Form 3160-5 (February 2005)

# SUNDRY NOTICES AND REPORTS ON WELLS of use this form for proposals 45

#### Maljamar 15 Fed #1

## **Conditions of Approval**

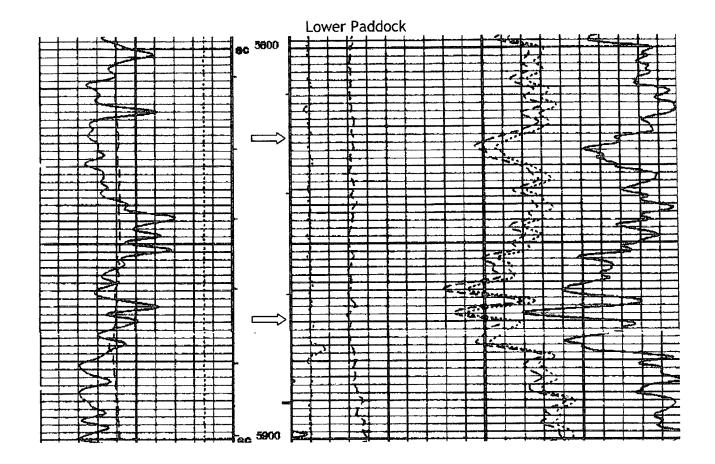
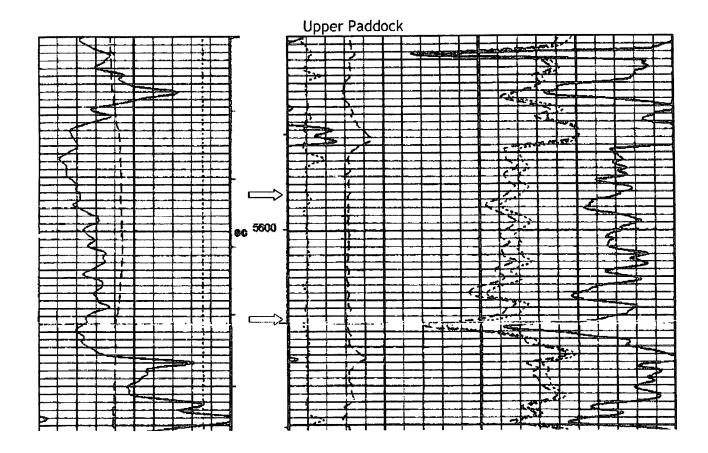
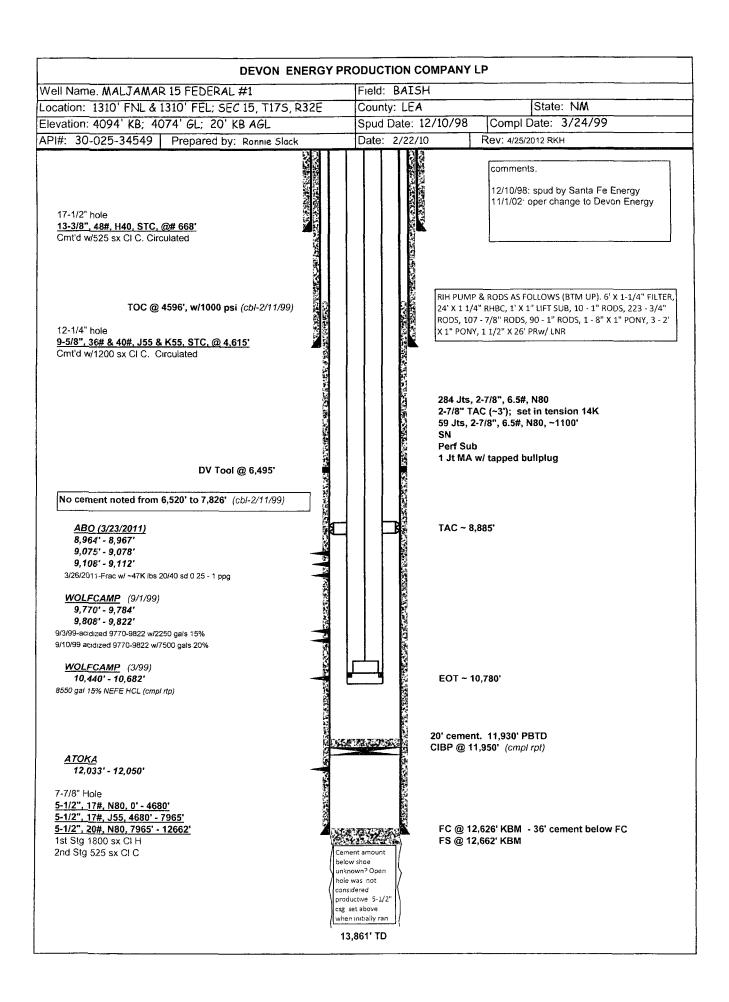
- 12. There is no record in this office that the retrievable bridge plug set at 9242' was removed. The operator may want to verify.
- 13. Step 3 of NOI: Tag CIBP at 11950' and place a minimum of a 25 sack Class H neat cement plug. Sample the cement slurry for weight and set up time.

- 14. Step 4 of NOI: Set CIBP at 9720', tag CIBP and place a minimum of a 25 sack Class H neat cement plug. Sample the cement slurry for weight and set up time.

- 15. Step 4a of NOI: Set CIBP at 8910', tag CIBP and place a minimum of a 25 sack Class H neat cement plug. Sample the cement slurry for weight and set up time.

- 16. Step 4b of NOI: Spot a minimum of a 35 sack Class C neat cement plug across the DV Tool (6600'-6400'). Sample the cement slurry for weight and set up time. Plug shall be tagged at 6400' or shallower. For any plug that requires a tag or pressure test a minimum WOC time of 4 hours(C) is recommended.

- 17. CIBP at 6270' approved as written.
- 18. Note: When permanently abandoned, operator shall drill out the CIBP at 6270', DV tool plug and CIBP at 8910' and then set a plug at the top of the Wolfcamp, top of Abo, and across the DV tool at 6505' before plugging the upper portion of the hole.

- 19. After setting the top plug and before perforating, perform a BLM-PET witnessed charted casing integrity test of 500 psi. The 5 ½", 17#, J55 casing installed at this depth would not be approved for installation by this office because of its burst safety factor. Pressure leakoff may require remediation prior to continuing with procedure. Include a copy of the chart in the subsequent sundry for this workover.
